RE: 136368/AO/2023 Application

Many thanks for the updated drawings for the external terrace lighting for 136367/FO/2023. We very much appreciate the work that has put into this to find an agreeable solution.

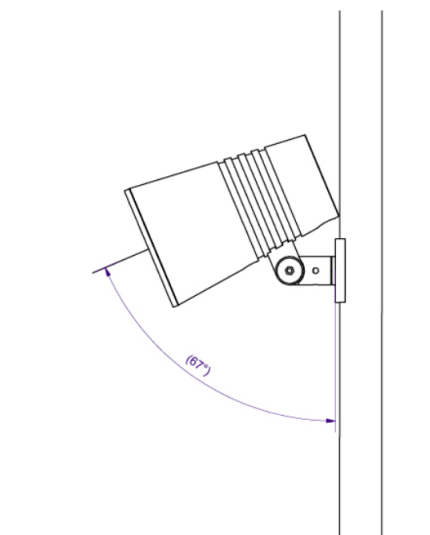
In terms of the terrace lighting, the project team have considered the concerns raised and have provided the following rationale to support the current proposals:

The existing Terrace was previously unused by the tenant client, with the current proposed scheme the external Terrace becomes an integral part of the NatWest fitout. The terrace will sit adjacent to the building's new staff café on level 7 and therefore the opportunity is there for staff to utilise the terrace with new external furniture and substantial amounts of biophilia as well as providing access to fresh air and sunlight.

To make use of the terrace it's necessary to provide appropriate lighting, the legacy lighting on the existing Terrace, was a single line of 4no. 1m tall bollard lights which only provided minimal circulation light levels not appropriate for the intended utilisation.

We need a solution that provides suitable lighting to illuminate the table surfaces and allow staff to safely circulate around the terrace. As such a pillar light arrangement with fixed downward facing light heads was deemed the most appropriate way to deliver the minimal number of pillars and head fittings.

The low-level bollard type fittings as were existing don't readily provide this lighting arrangement.

The light fittings at the head of the pillars can be locked in a downward position thus avoiding any risk of these fittings pointing away from the building or indeed skyward. The fittings would be focused and concentrated on the Terrace to allow staff to use the Terrace on darker days and into the evenings, as can be seen in the image below, the fitting has a limiting angle to prevent upward light output.

The proposed luminaires can also be dimmed therefore adjustments to the lighting levels can be made once installed to follow any lighting level limitations.
